Re: Greater Macarthur Land Release Proposal (GMLR) incorporating the conurbations of  
Menangle/Wilton/Appin - Stakeholder Feedback

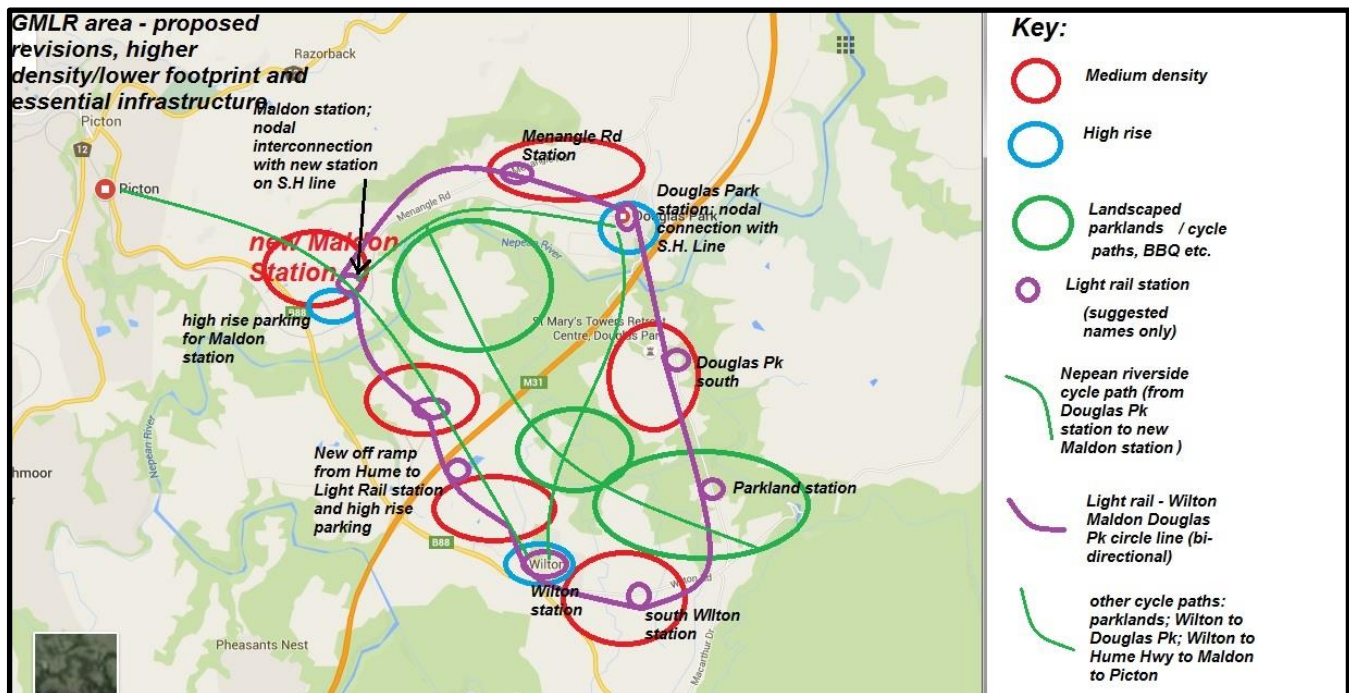
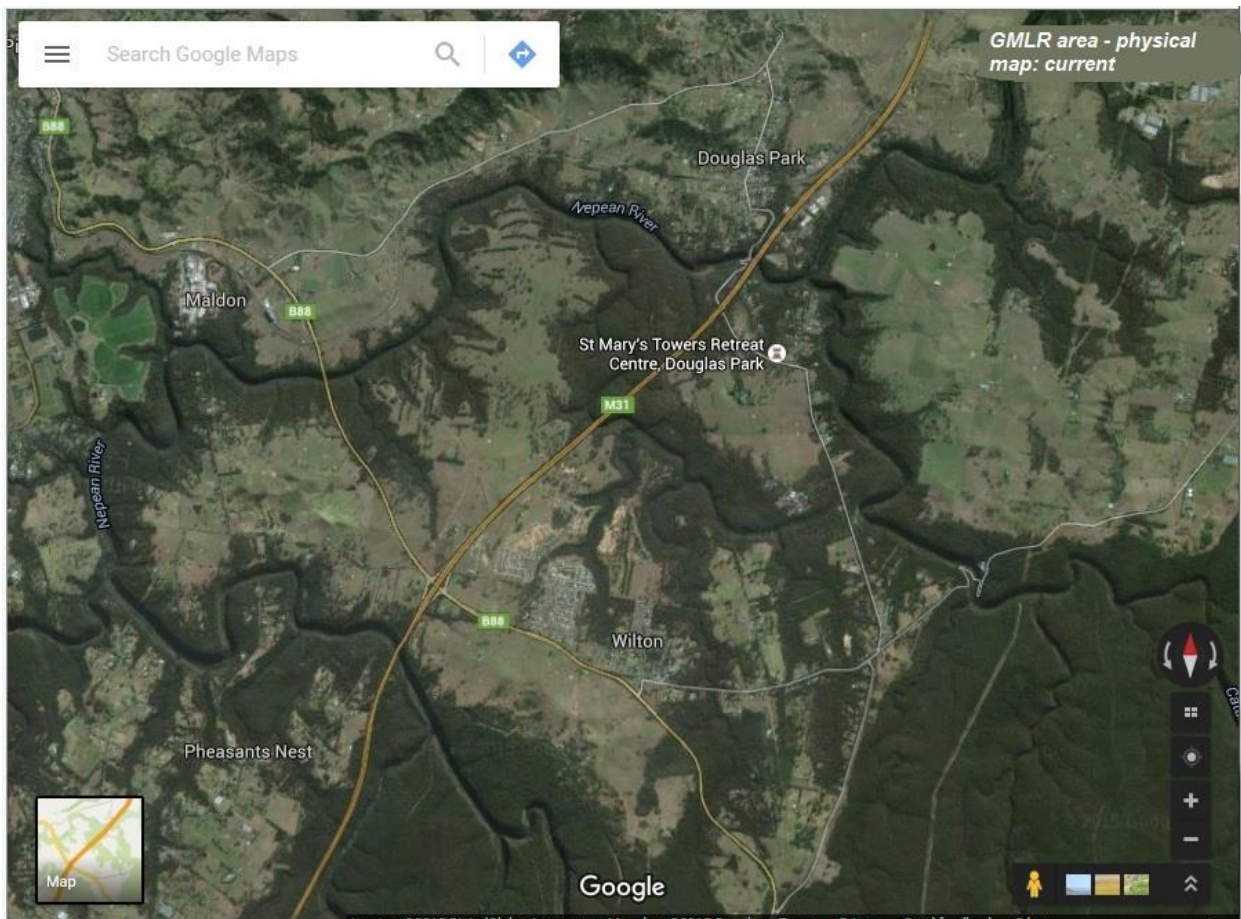
1. That the environmental footprint is about ¼ of the current size.
2. That the density is correspondingly 4x the current density, and that density conforms to standard world’s best practice for urban areas – generally between 4-8 storeys.
3. That light rail is built connecting all parts of the GMRL area with each other and with the two closest stations on the Southern Highlands line in a circle line (see map). That is, Maldon, the Hume Hwy, Wilton and Douglas Park are connected together with a bi-directional driverless circle line light rail system, that interconnects with the Southern Highlands line (see map)

In general, this means that densities are compressed to allow for the critical cultural mass to occur that makes the car obsolete within the neighbouring area of the release. Note that residents could still own a car, and they could still use their cars to travel to the beach or to Canberra or to anywhere else. But travel within the GMLR would be enabled through a single PT automated light rail line that connected both sides of the release area on both sides of the Southern Highlands railway line with the two stations of Maldon and Douglas Park (see map), entirely integrating the growth region with a baked-in PT network, and obviating the need for a car. Note that the separation of areas into the 'pearls' is not following the Canberra model, which had low density and separation. This is separation and connection via automated light rail (the 'string') and medium and high density (the 'pearls').

Medium rise of 4-8 storeys of spacious terraces, rows of houses, and apartments, with cutting edge design and amenities would characterize 90% of development.
